Re: Response to Request for Additional Information, Geologic Characterization and Area of Review (AoR) Delineation Modeling,
Carbon TerraVault Holdings LLC (CTV) VI Project
Underground Injection Control (UIC) Permit Application
Class VI Pre-Construction Permit Application No. R9UIC-CA6-FY24-2.1 to 2.7

Carbon TerraVault Holdings LLC (CTV) has prepared this response to the U.S. Environmental Protection Agency Region IX ("EPA") CTV VI Class VI Permit Application request for additional information dated May 15, 2025. Responses to each EPA comment are attached to this letter. The following permit application components have also been revised in response to EPA comments:

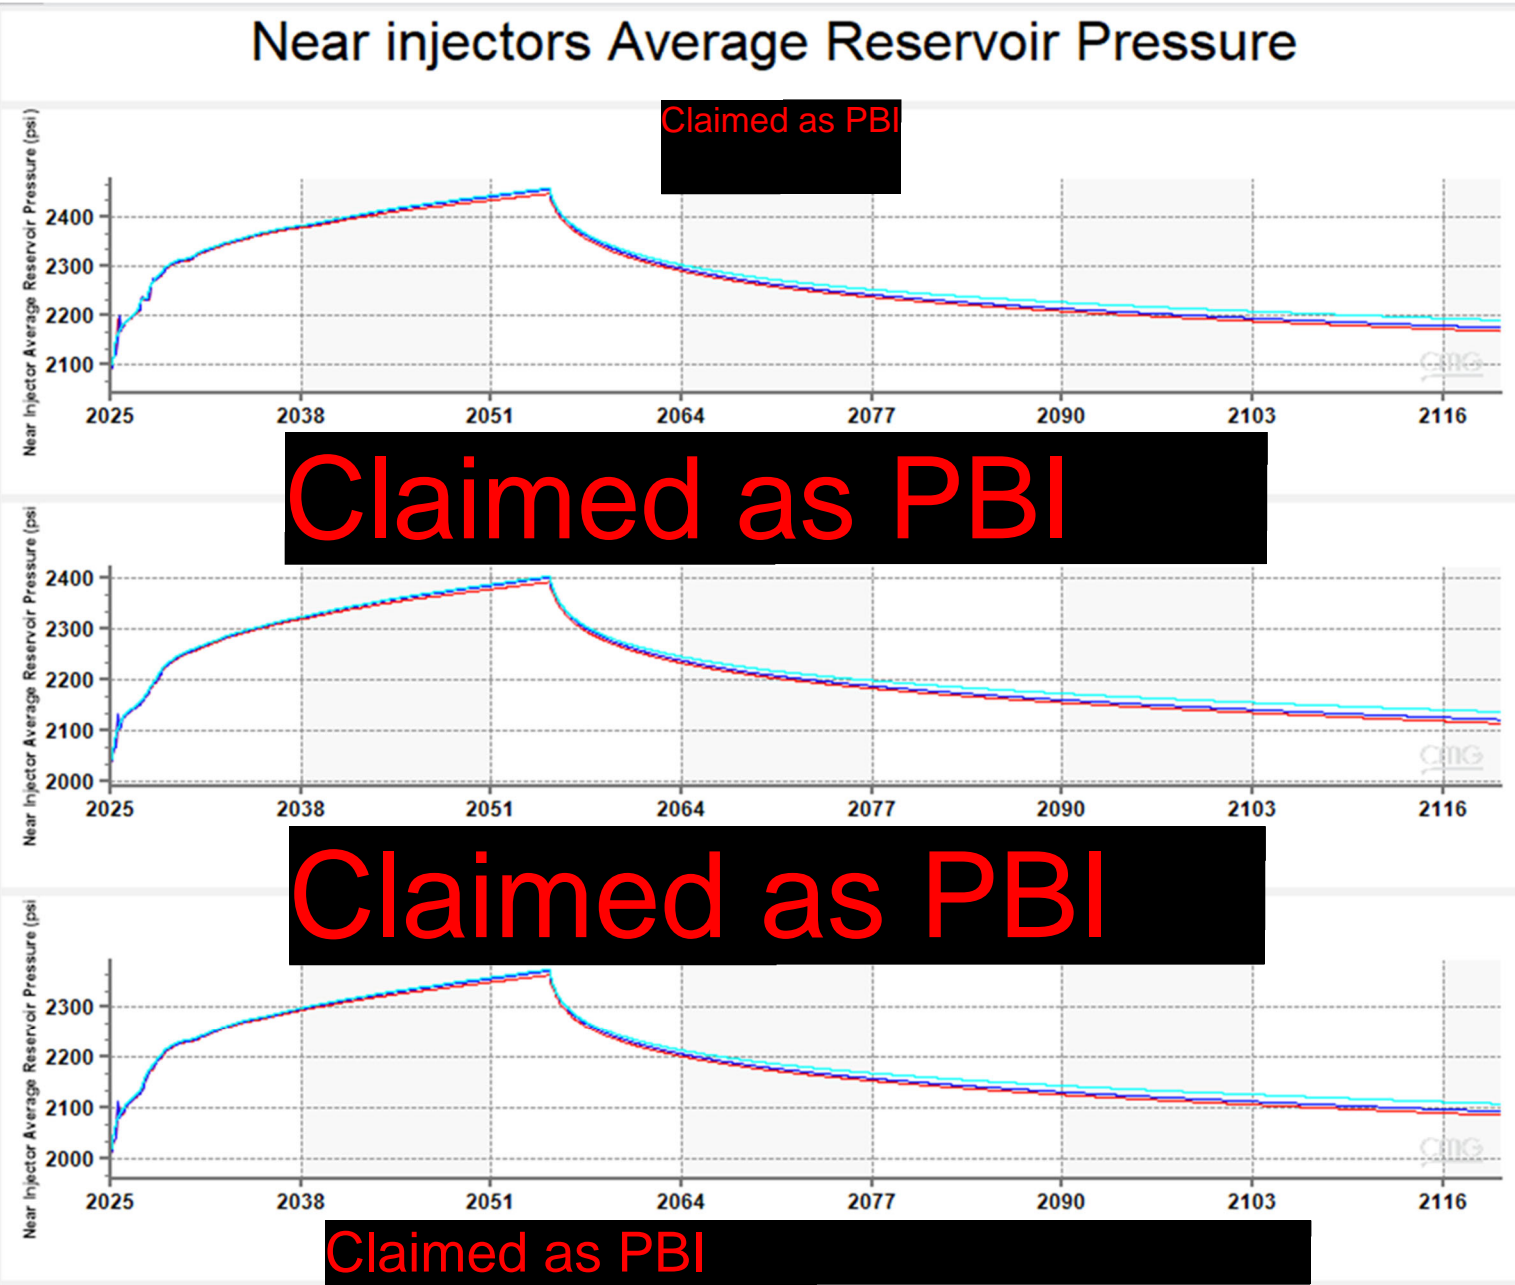
Section	Q #	Comment/Question for CTV	Text Section Updated	CTV Response
Overall Findings (cont.)	5	A better description of the thermal modeling needs to be included. <i>Was temperature simulated? If thermal transport was simulated, a figure showing the impact of the injection temperature on the formation should be included.</i>	None	<p>CMG GEM accommodates non-isothermal reservoir conditions by incorporating an energy equation to compute temporal temperature distributions in the reservoir during compositional processes where reservoir temperature may vary.</p> <p>A sensitivity analysis with the thermal option enabled was completed on the Claimed as PBI Injection Zone to demonstrate the impact of non-isothermal effects. The analysis was limited to a single injection zone and without local grid refinement to preserve computational efficiency. Compared to the isothermal full field model, the non-isothermal Claimed as PBI only model produced a minimal difference in plume boundary delineation and average reservoir pressure. See Figures RtC-2 and RtC-3 at the bottom of this matrix.</p>
